# UNITED STATES PATENT AND TRADEMARK OFFICE

| APPLICATION NO. | FILING DATE | FIRST NAMED INVENTOR | ATTORNEY DOCKET NO. | CONFIRMATION NO. |
|-----------------|-------------|----------------------|---------------------|------------------|
| 10/798,020      | 03/11/2004  | Otto Schempp         | 2133.028USU         | 5894             |

| <b>Office Action Summary</b> | <b>Application No.</b> |  | <b>Applicant(s)</b> |  |

## DETAILED ACTION

**FIGURE A**

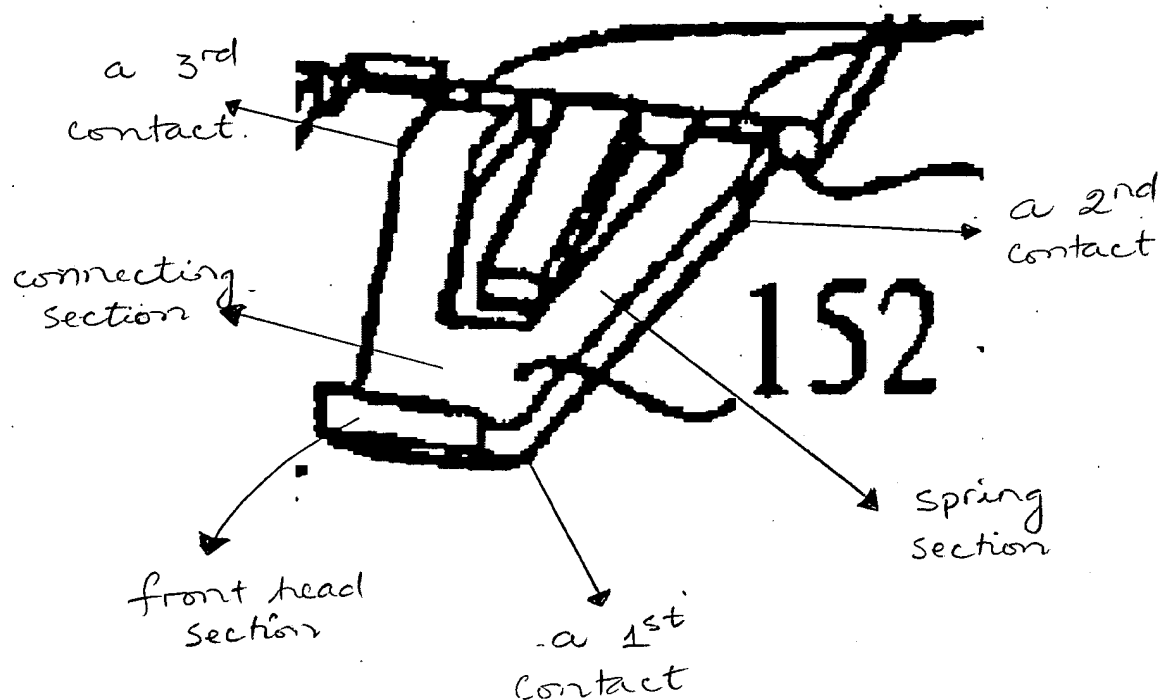
- a plurality of signal terminals (88) that are arranged in the housing (since the terminals 88 are connected to signal terminals 54 of the header contacts 24 (column 10, lines 5-9); therefore, 88 are the signal terminals); and
- at least one ground terminal (84, figure 4) with at least a first contact section (152) and a first spring arm section (not labeled), with the first contact section having at least one first and second contact (a FIGURE A below), wherein the first and second contacts are mechanically coupled.

Regarding claim 38, the first contact section comprising a third contact (the FIGURE A below)

Regarding claim 40, a front head section (the FIGURE A below) on which the first and second legs are connected to one another, and the first contact is arranged on the head section, the second contact is arranged on the first leg, and the third contact is arranged on the second leg.

Regarding claim 42, the first spring arm section having a connecting section (the FIGURE A below) and a spring section (the FIGURE A below), wherein the spring section being inclined with respect to the connecting section.
